REQUEST

Current Zoning: I-1(CD) & R-22MF (light industrial, conditional & multifamily residential)
Proposed Zoning: UR-2(CD)

The petition proposes to allow up to 270 multifamily residential units on a vacant site in the Lakepointe Corporate Center office park.

PLANNING STAFF REVIEW

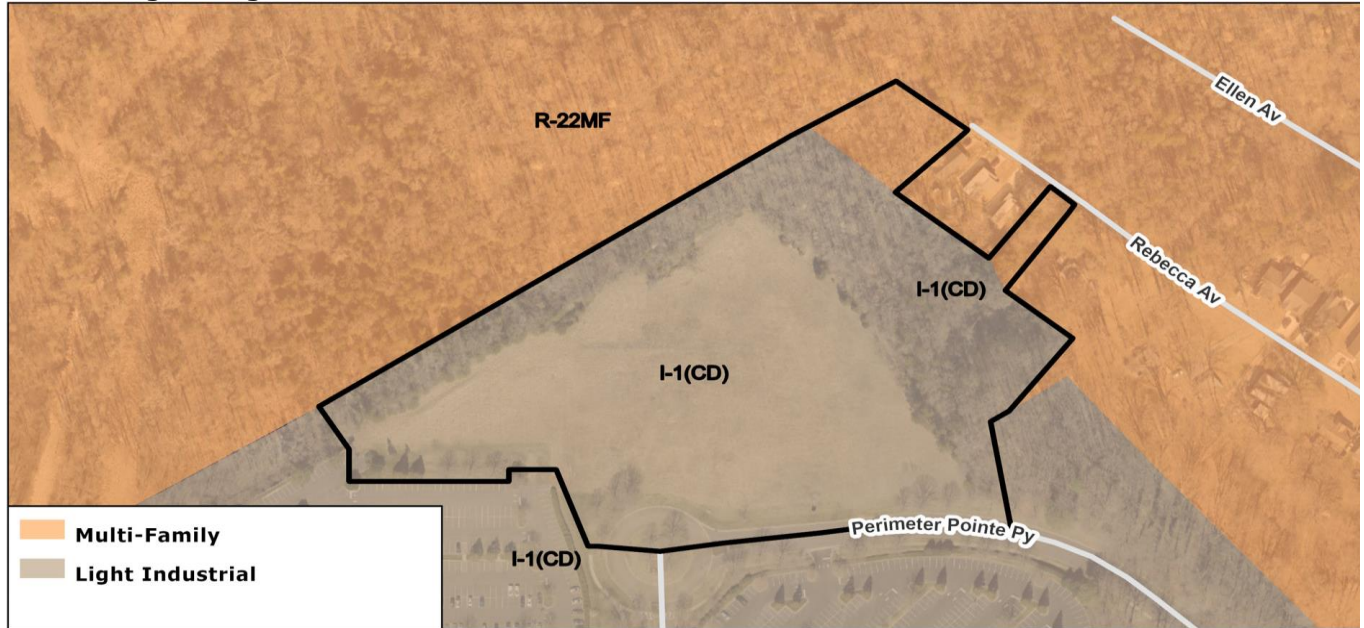
OUTSTANDING ISSUES

1. Revise site plan to provide a splitter island at the proposed roundabout leg so that the sidewalk goes through it. The splitter island pedestrian walkway width should mirror the width of the sidewalk to provide sufficient protection for pedestrians.

2. Provide a tree survey identifying all trees of eight-inch DBH or greater and all planted trees of two-inch caliper or greater and six feet in height that grow partially or wholly within the city right-of-way.

3. Clarify the line shown between the solid waste area and property line.
4. Remove the word "fence" from note 5.k.
